## **PLANNING AND ZONING COMMISSION AGENDA**

**STAFF REPORT  
KETCHUM PLANNING AND ZONING COMMISSION  
REGULAR MEETING OF OCTOBER 24, 2016**

**REVIEWER:** Brittany Skelton, Senior Planner

The applicant is requesting a Conditional Use Permit (CUP) to allow redevelopment of 911 N. Main for a motor vehicle fueling station and a food service establishment. Motor vehicle fueling stations and food service (subject to limitations on hours of operation and size) are only allowed in the LI-1 District if a Conditional Use Permit (CUP) is approved. The definition of motor vehicle fueling station permits retail sales of items of convenience to the motoring public. The Planning and Zoning Commission (Commission) has complete discretionary authority to approve, deny, or conditionally approve either use (fueling station or restaurant) or approve, deny, or conditionally approve both uses on the site, basing the decision upon findings of fact.

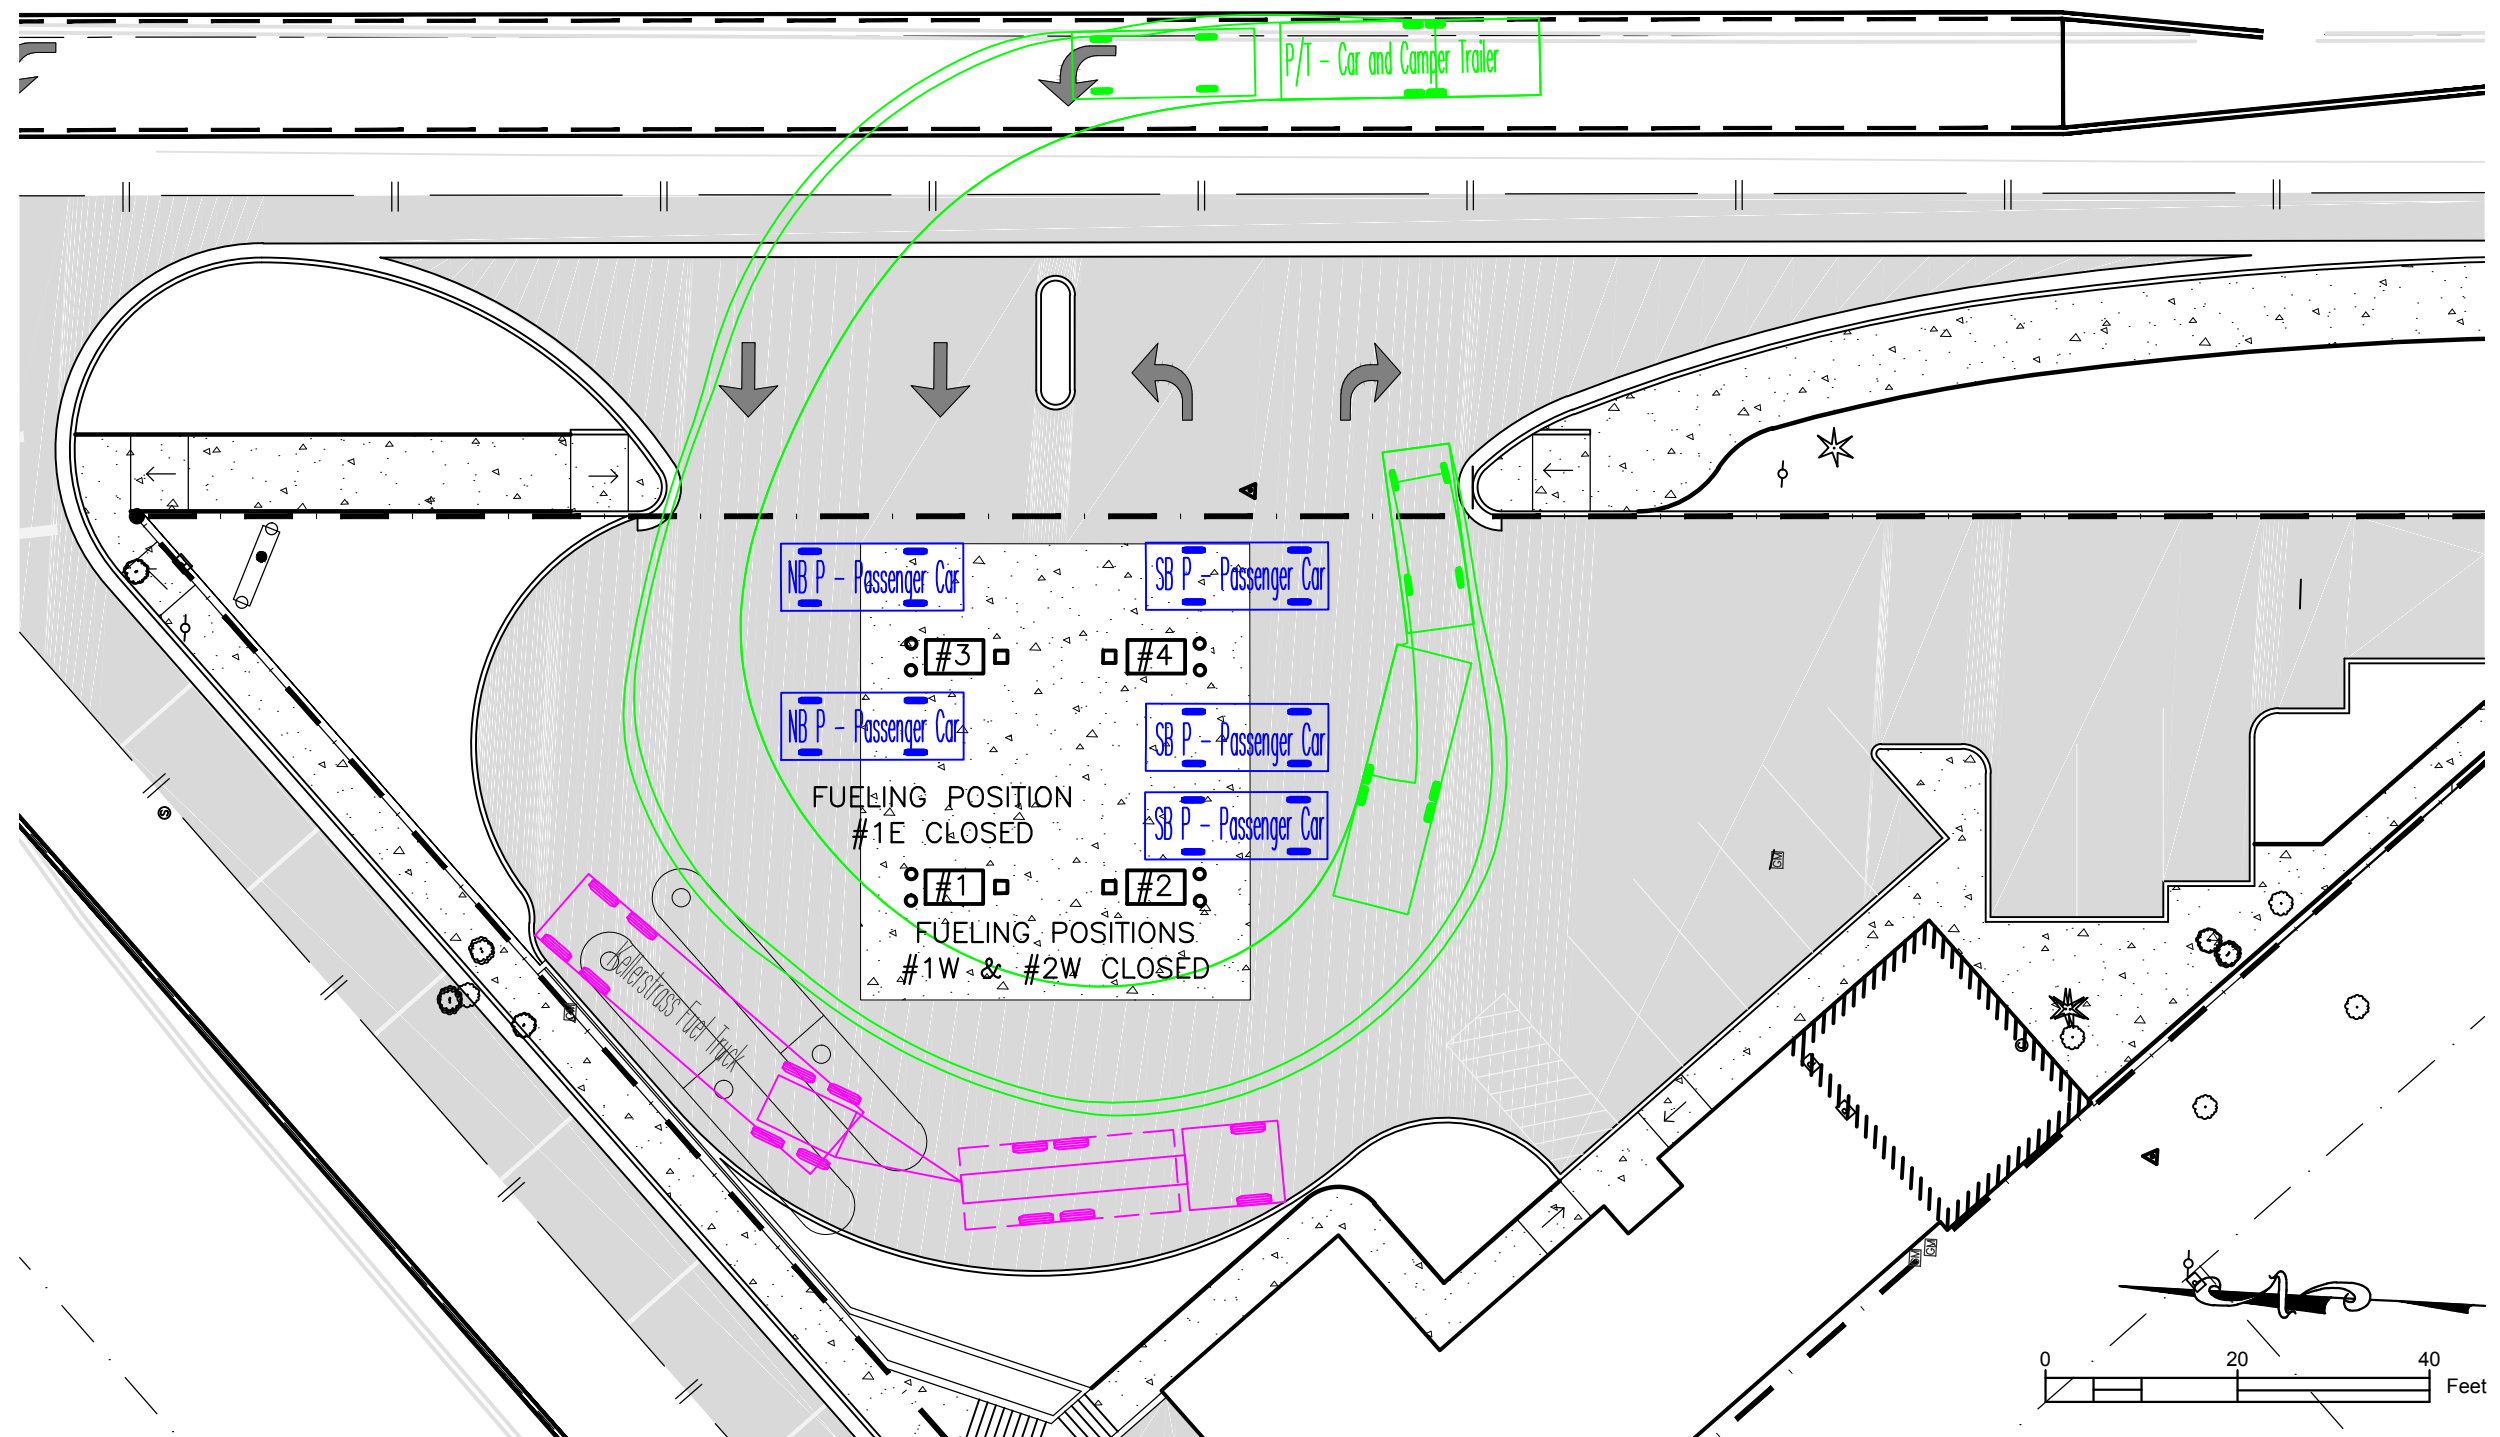
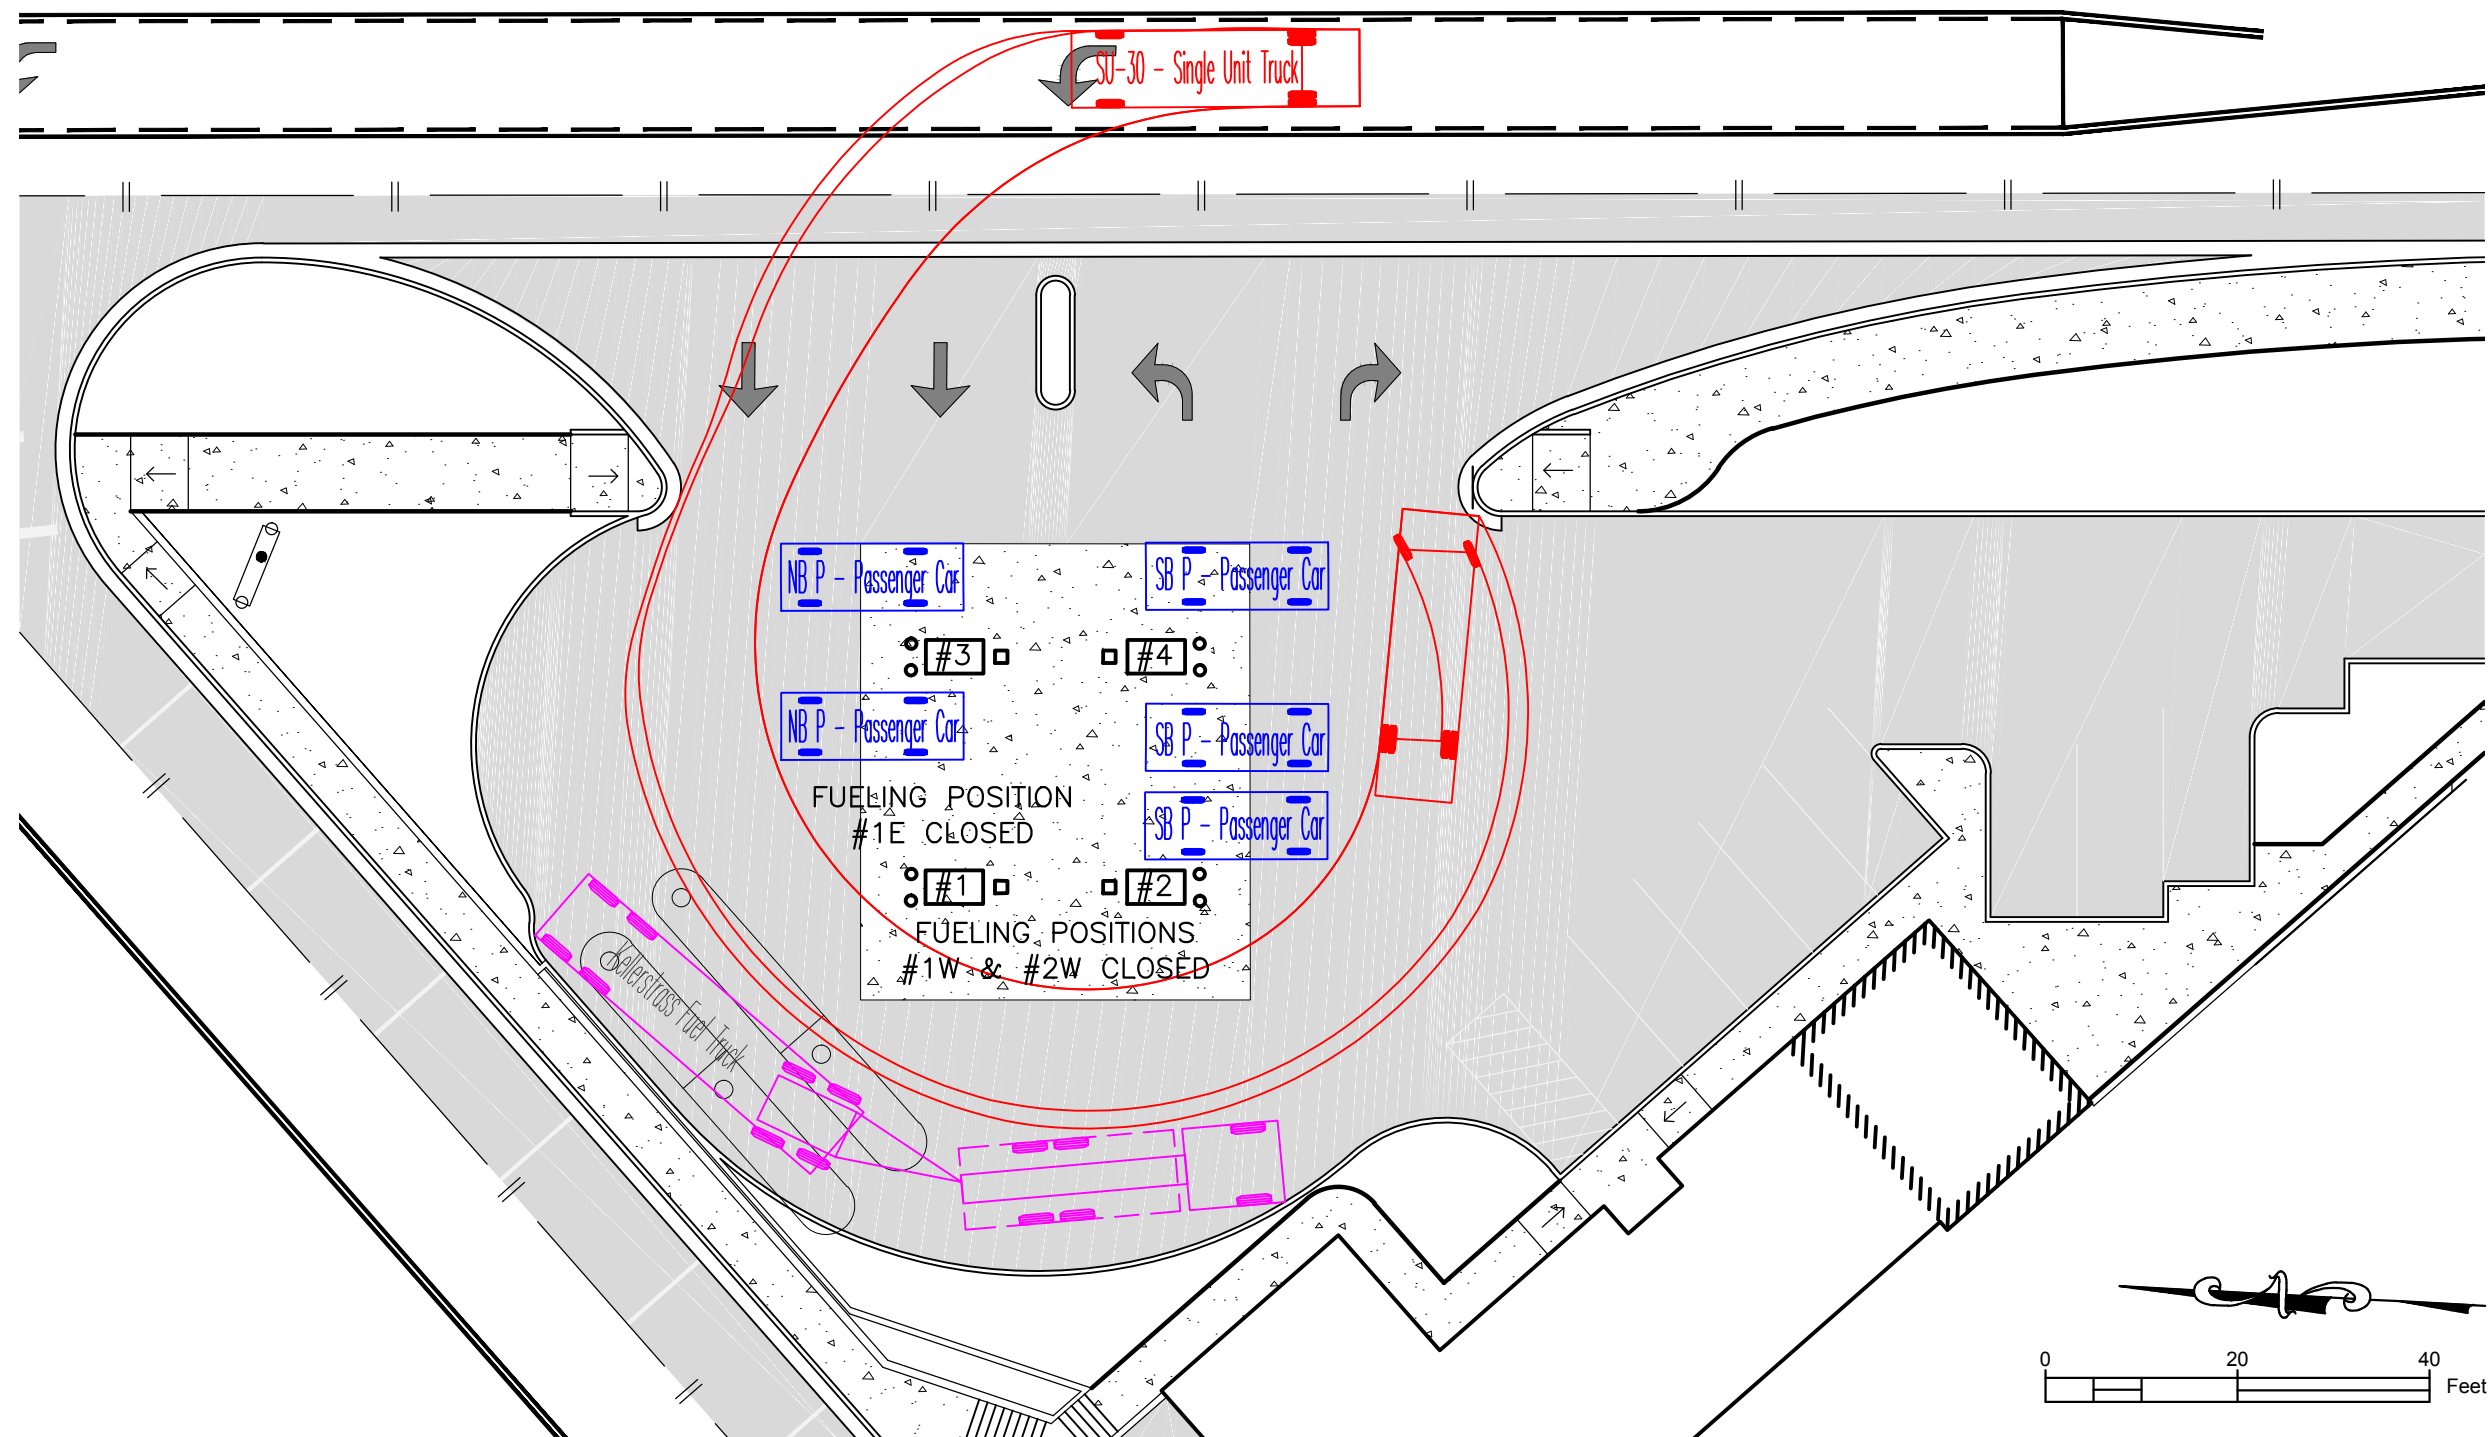
<b>Box Truck Access and Circulation</b>	<p>This exhibit depicts several circulation scenarios of northbound and southbound box trucks.</p> <p>There are no stationary vehicles parked on site.</p>	<p>This exhibit illustrates four possible maneuvers of northbound box trucks and two possible maneuvers of southbound box trucks to circulate the site.</p> <p>Staff's concerns:</p> <ol style="list-style-type: none"> <li>1. Northbound - There are only two fueling positions possible, fueling on the east side of pump #1 and fueling on the east side of pump #2, with fueling at pump #2 dependent on pump #1 being open in order for the box truck to maneuver into position;</li> </ol>

<ol style="list-style-type: none"> <li>2. Southbound – While there are several scenarios for fueling available, half of the scenarios require two pumps in tandem to be available at the same time in order to access the southernmost pumps;</li> <li>3. Maneuvering into the loading zone is dependent the east side of pump #4 to be open;</li> <li>4. Multiple scenarios require the box truck to drive onto the curb;</li> <li>5. If a box truck fuels at pump #3 or #4 the length of the vehicle may encroach into the area north of the fueling island that all vehicles use as ingress to circulate the site; and</li> <li>6. Fueling at pump #2 as depicted in the exhibit encroaches into the area south of the fueling island that vehicles use to circulate to the parking spaces.</li> </ol>
<b>Fuel Truck Delivery – RV Circulation</b>	<p>This exhibit depicts a northbound passenger vehicle towing an RV circulating the site while a fuel delivery truck is on site.</p> <p>There are 5 passenger vehicles positioned at fuel pumps.</p>	<p>This exhibit illustrates that when a fueling truck is on site in the fueling location and the east and west sides of pump #1 are closed and the west side of pump #2 is closed a passenger vehicle towing an RV can circulate onto the site and maneuver past the fuel truck to queue near the exit or exit the site.</p> <p>Staff's concerns:</p> <ol style="list-style-type: none"> <li>1. Benchmark did not have enough information to accurately model the fuel delivery truck in motion and was not able to show the turn movements of the fuel delivery truck entering the site and maneuvering into position; staff cannot analyze the ability of the fuel delivery truck to make the maneuvers while pumps #1 and #3 are occupied and therefore is concerned about the queue in the turn lane while the fuel delivery truck circulates on the site;</li> <li>2. The applicant has provided a letter from Dallas Green, Director of Operations of Kellestrass Oil, stating that the timing of fuel delivery truck trips to the site can be scheduled. However, conditioning approval of the Conditional Use Permit to include conditions of the times that fuel and retail deliveries can occur is a challenging and burdensome condition to continually enforce in perpetuity.</li> </ol>
